ROLLING KNOLLS LANDFILL SUPERFUND SITE
FEASIBILITY STUDY ASSESSMENT

The Office of Environmental Policy and Compliance

KMPower Consulting, Inc

April 2019

FIGURE 3 - Refuge Area of Interest
Pb Surface Soil Soil Concentrations

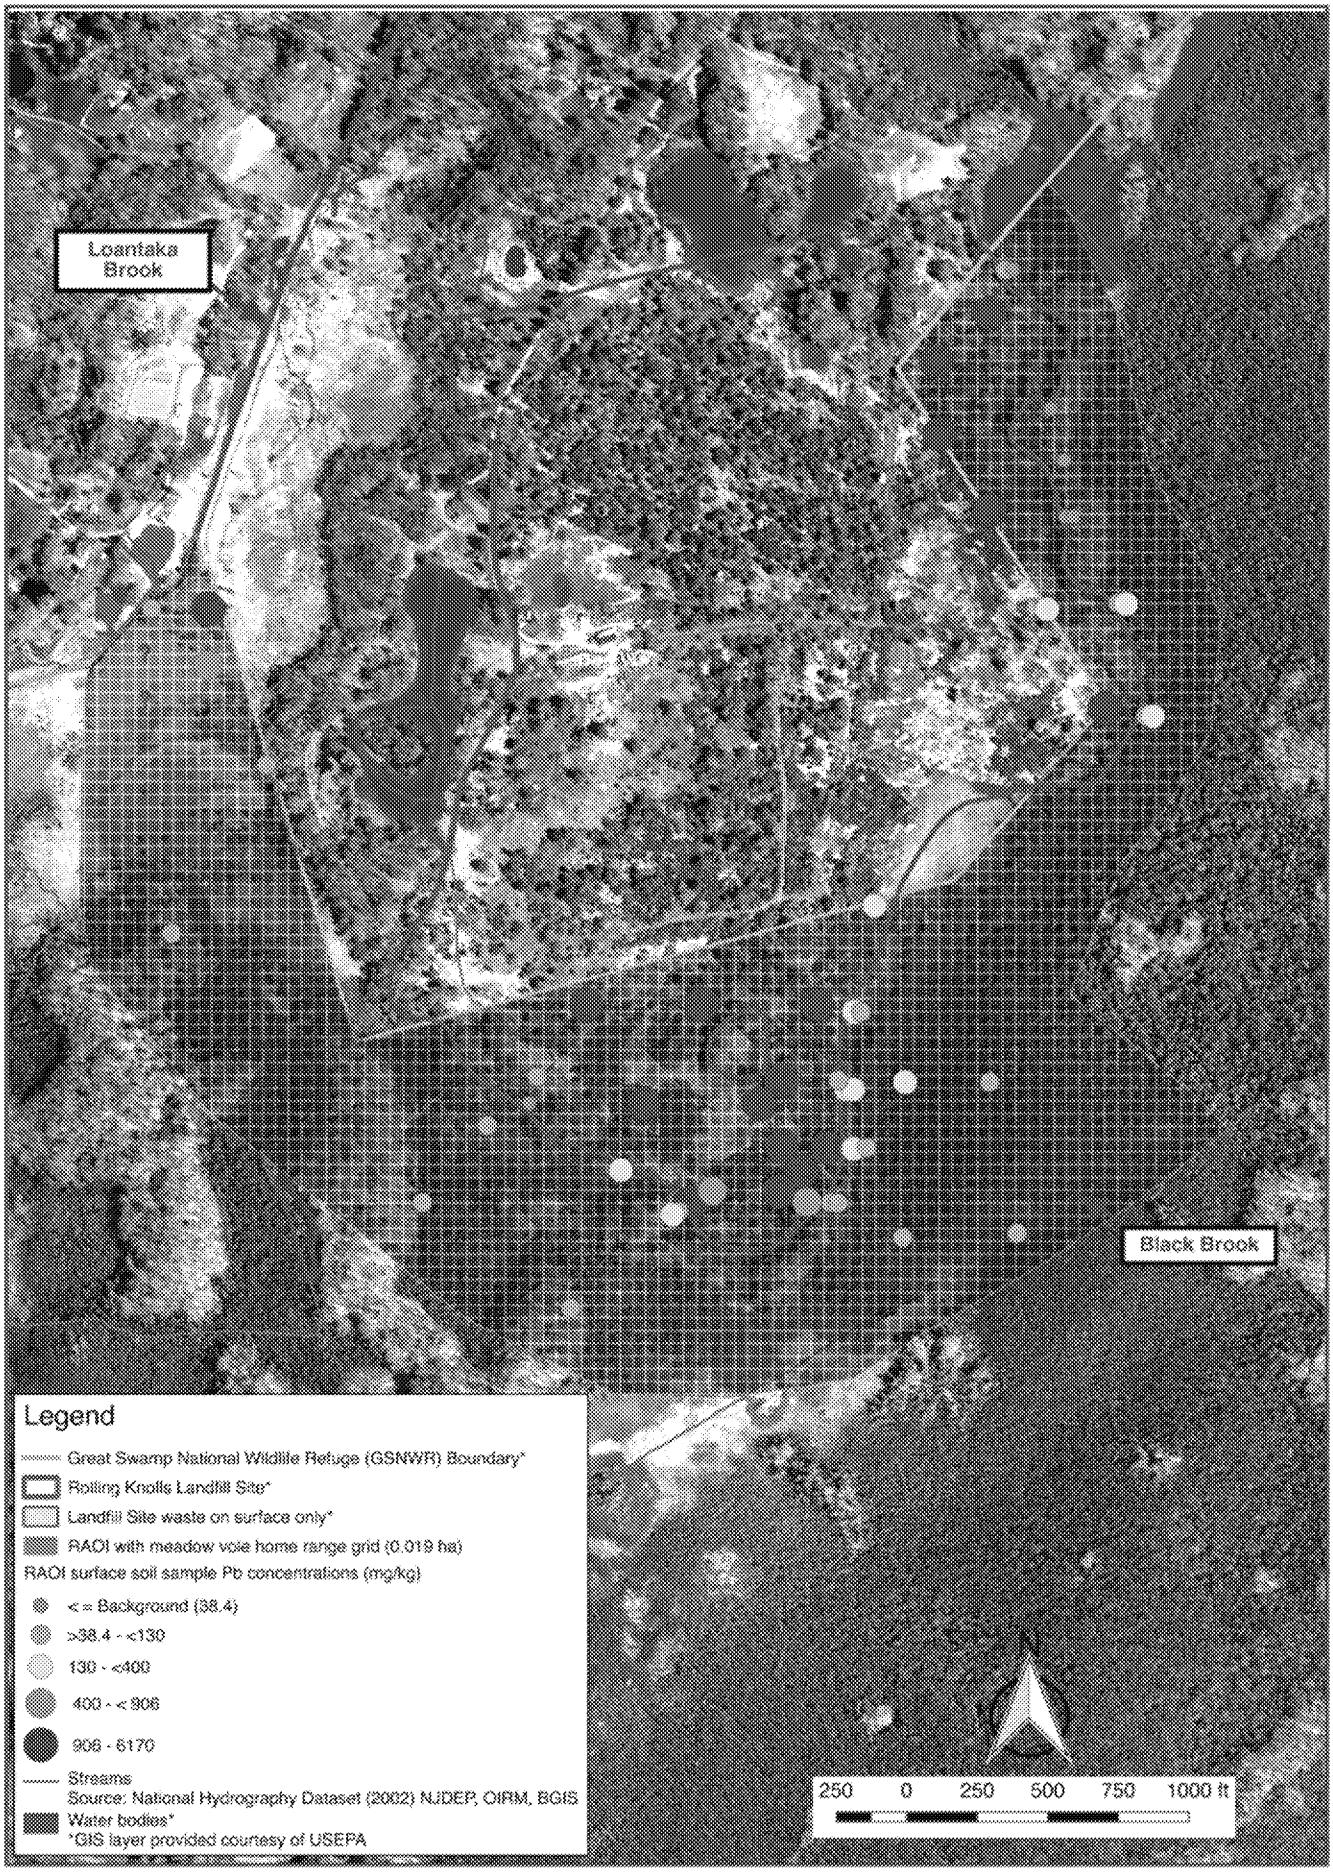
Figure 3 – Figure 3 illustrates several main points of impact revealed by the assessment on the RAOI property from Table 1. Features of Figure 3 include:

- A grid of 0.019 Ha (2045 ft^2) cells across the RAOI, which represent an array of small herbivorous mammal exposure areas such as the meadow vole (the meadow vole was identified in the BERA as the representative species for this receptor group). As indicated, the meadow vole home range is relatively small compared to the potentially impacted area of the RAOI. The question marks on Figure 3 mark boundaries beyond which insufficient data exists for the Agencies to make an assessment of impacts (i.e., the extent is not delineated).

- A gradient of Pb concentrations across the RAOI is apparent. As indicated in the legend, and marked by the colors of the lead sample results, four general groupings of results are identified:

- Based on this assessment, the RAOI has been adversely impacted by Pb contamination associated with the landfill wastes and that the impact is significant. Proposed remedial alternatives in the draft FS that do not fully contain the source landfill waste to prevent further migration of Pb into the Refuge do not adequately address contamination on the RAOI. The selection of any of these alternatives for the Site would not comply with NJDEP remediation requirements, the Refuge CCP, the DOI ECM requirements, or other Refuge ARARs (DOI 2018).

- As indicated above and illustrated on Figure 3 a significant portion of the soils with Pb contamination exceeding the Table 1 benchmarks on the RAOI are found in the South/Southeast impacted area of the RAOI. An area of approximately 17.8 acres contains all the sample locations with Pb concentrations higher than the 400 mg/kg benchmark concentration and includes measured concentrations as high as 6,170 mg/kg. Furthermore, this area is only characterized by 23 samples (i.e., approximately only 1.3 samples per acre; see also discussion below regarding Figure 4). Potentially, localized regions or 'hot spots' could be present that have not been identified. As indicated on Figure 3, relative to the herbivorous mammal exposure areas (the 2045 ft^2 cells, voluminous uncharacterized areas are present in the South/Southeast impacted area of the RAOI.

FIGURE 4 - Refuge Area of Interest
Pb Surface Soil Impacted Areas

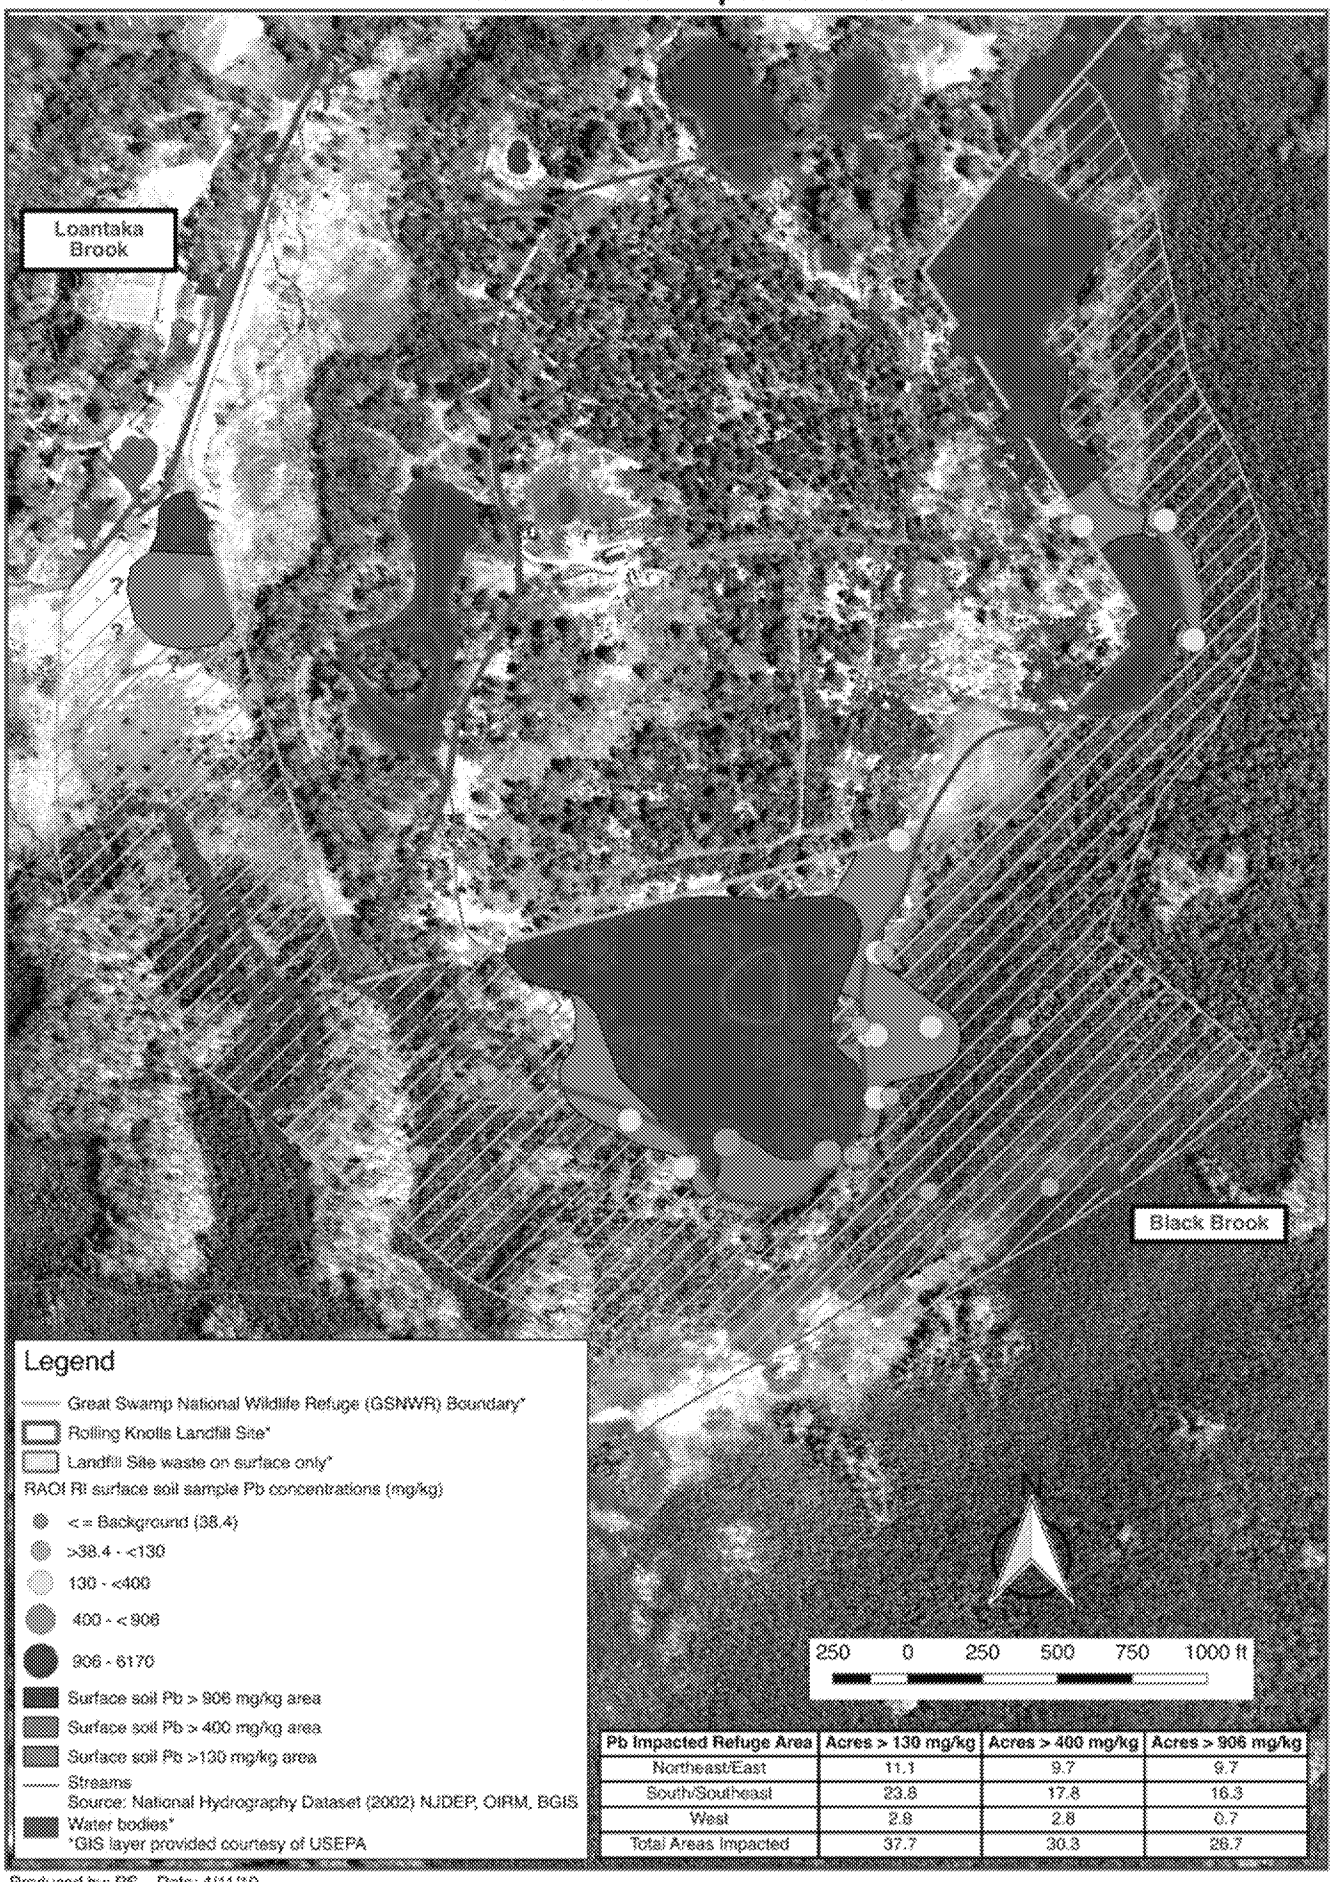
Figure 4 – The extent of lead contamination in the RAOI is further illustrated in Figure 4. Polygons were created to delineate approximate areas of contamination exceeding the key benchmarks. The polygon boundaries were determined based on their proximity to adjacent samples, the Pb concentrations of adjacent samples, and professional judgment. A review of the data illustrated on Figure 4 results in the following observations.

- Three main areas of Pb contamination are delineated on the RAOI: Northeast/East, South/Southeast, and West areas

The information provided in Figure 4, indicates the following:

1. It appears that a significant area of the impacted RAOI area surface soils may contain Pb concentrations exceeding the meadow vole NOAEL-based protective benchmark concentration of 906 mg/kg, including:
    - The Northeast/East (9.7 acres).
    - The South/Southeast portion (16.3 acres).
    - The West area (0.7 acres), which is located outside of the landfill boundary/currently-defined Site.

Overall, it is estimated that approximately 26.7 acres of soil could be impacted on the RAOI with Pb concentrations exceeding the meadow vole NOAEL-based protective benchmark concentration of 906 mg/kg. Given the relatively small meadow vole home range and the large RAOI area impacted, it is conceivable that a significant portion of the small mammal population, as represented by the meadow vole, could be at risk from Pb concentrations above the NOAEL benchmark.

2. Based on the distribution of contaminant concentrations, it is likely that a sizable portion of the RAOI may contain areas where Pb surface soil concentrations exceed the assessment benchmark concentration of 400 mg/kg including:

Overall, it is estimated that approximately 30.3 acres of impacted soil could exist on the RAOI with Pb concentrations exceeding the benchmark Pb concentration of 400 mg/kg.

3. Figure 4 also indicates that a significant area of the impacted RAOI area surface soils may contain Pb concentrations exceeding the Short-tailed shrew NOAEL-based protective benchmark concentration of 130 mg/kg, including:

Overall, it is estimated that approximately 35 acres of soil could be impacted on the RAOI with Pb concentrations exceeding the meadow vole NOAEL-based protective benchmark concentration of 130mg/kg. Given Short-tailed shrew's home range of ~ 1 acre (0.39 hectare) and the potentially large RAOI area impacted (37.7 acres) it is conceivable that a significant portion of the small mammal population, as represented by the Short-tailed shrew, could be at risk from Pb concentrations above the 130 mg/kg NOAEL benchmark.

Based on the discussion above, proposed remedial alternatives in the draft FS that do not fully contain the source landfill waste and cover existing contaminated soil to prevent further migration of Pb into the Refuge do not adequately address Pb contamination on the RAOI. The selection of any of these alternatives for the Site would not comply with the NJDEP remediation requirements, the Refuge CCP, the DOI ECM requirements, or other Refuge ARARs (DOI 2018).

FIGURE 6 - Sediment Sample Locations

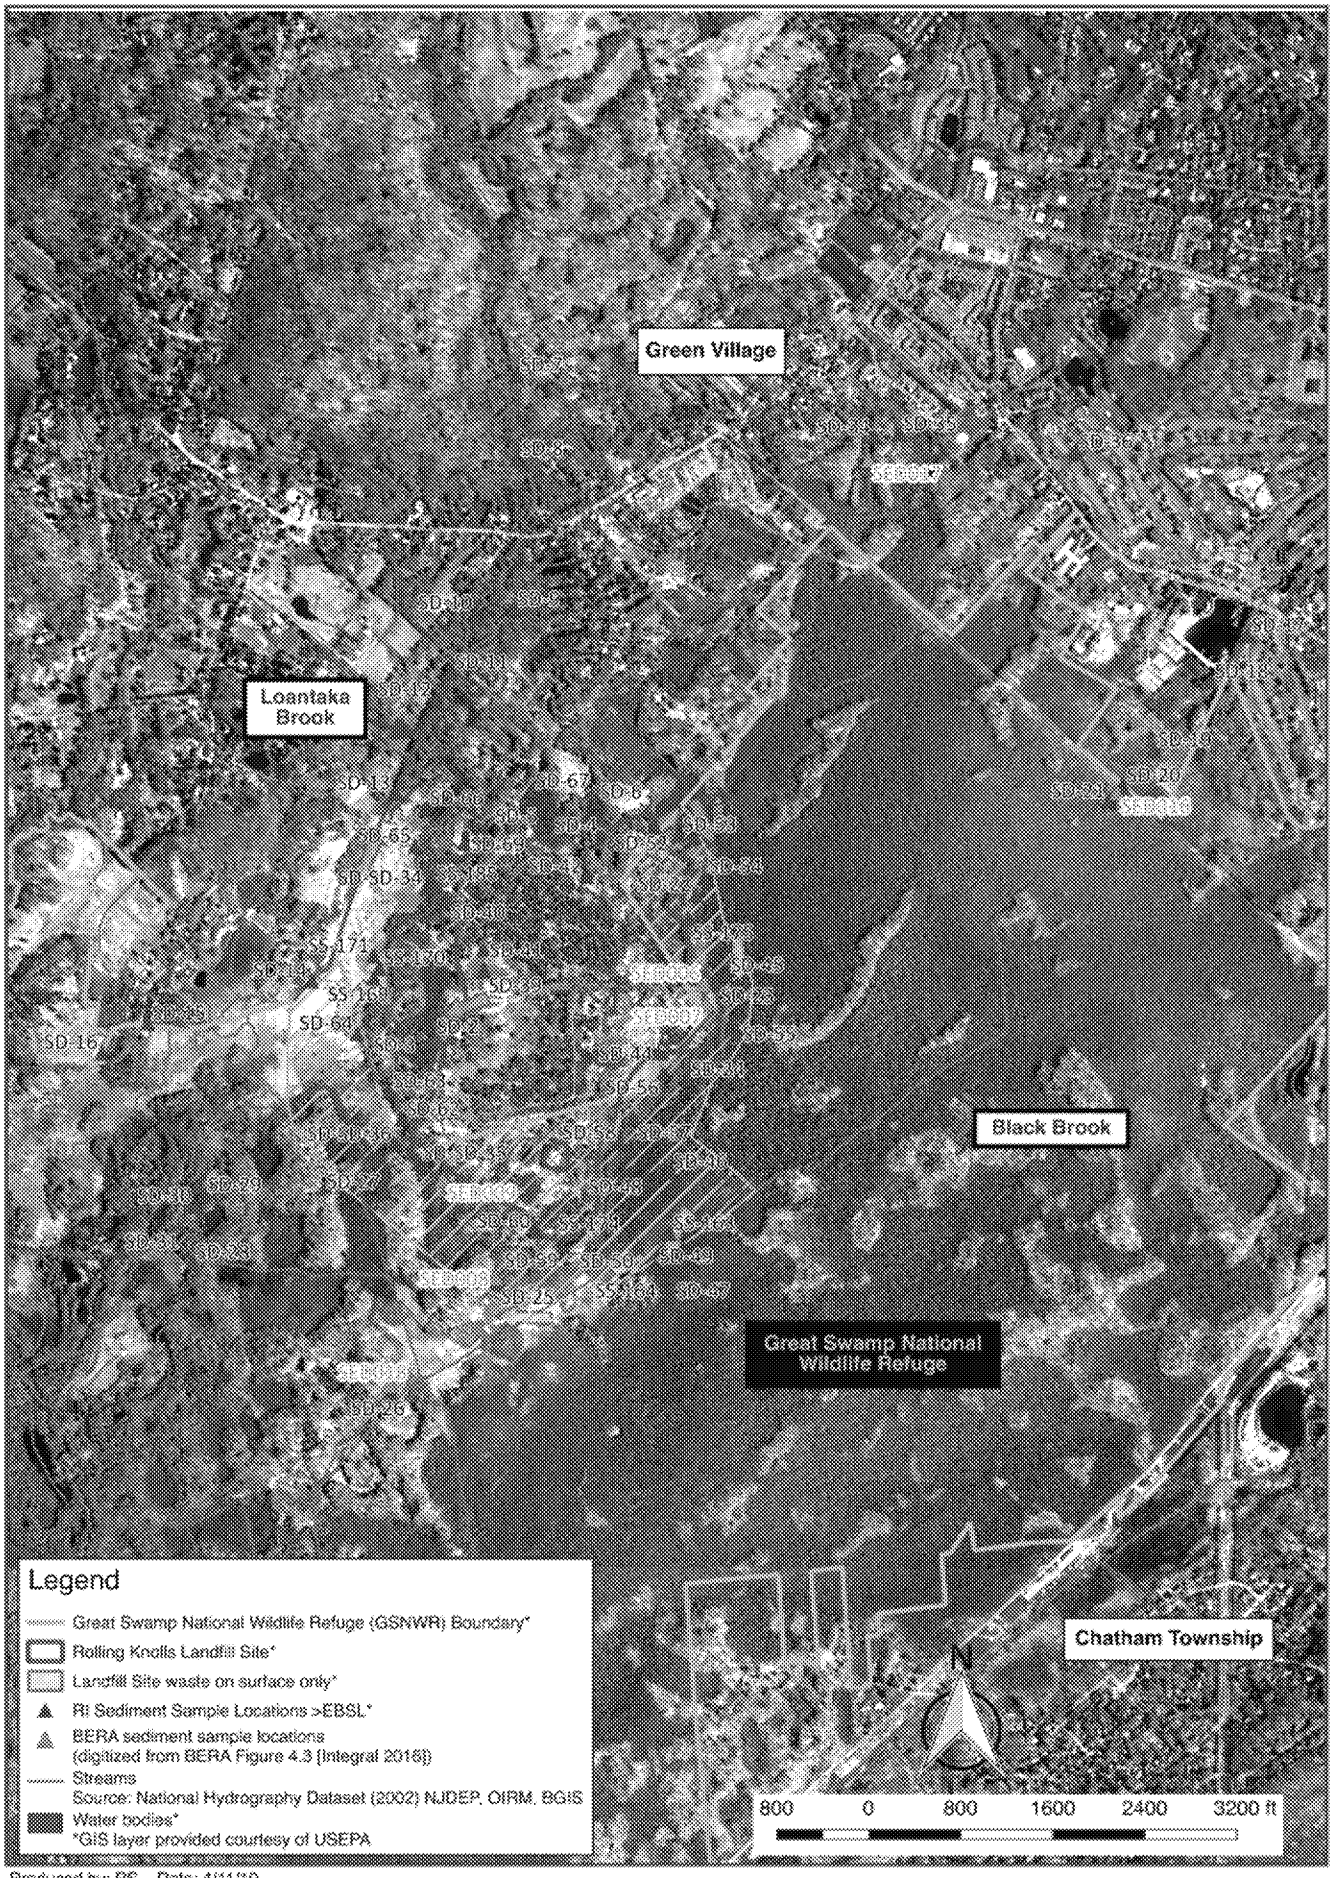
Sediment contamination has been identified as an issue of ecological concern and COPECS were evaluated in the BERA (Integral Consulting, Inc. 2016). The locations of BERA sediment data used in this evaluation are displayed on Figure 6. Figure 6 shows the location of sediment data collected and presented in the both the BERA and the RI. Notable in Figure 6 is the amount of RI sediment data that were not used in the BERA. Additionally, within the BERA sediment data, large areas were not sampled. Specifically, sediment samples were not evaluated in the BERA within Black Brook from the up-gradient location of SED 017, to sediment samples SED 006 and SED 007 (in close proximity to each other) on the eastern border of the landfill, which is a reach of approximately one mile (Figure 6). Additionally, there were no sediment samples evaluated between SED 007 and the most down gradient location, SED 018, which is also an approximately one mile reach (Figure 6). Overall, the reach from upgradient to downgradient sample locations is nearly two miles. Two additional sediment samples (SED 008 and SED 009) located in South/Southeast impacted area of the RAOI were included in the BERA. Concentration data used in this assessment was taken from the BERA, Figure 4-3 (Integral Consulting, Inc. December 2016) and the RI (Geosyntec Consultants, Inc. 2018a, Table B-7A).

Of interest is the profile of sediment COPECs in the flowing reach of Black Brook illustrated in Table 6 (See Figures 6 and 7 for locations). The relatively long run of Black Brook through the Refuge from the upgradient boundary, to SED 006 and SED 007 on the eastern border of the landfill, to SED 018 is nearly two miles (up-gradient sample location SED 017, is not actually on the Refuge [Figure 6]). Table 6 provides a comparison of sediment contaminant concentrations on the Refuge to NJ criterion at these locations. Notable are the consistent exceedances in samples SED 006 and SED 007.
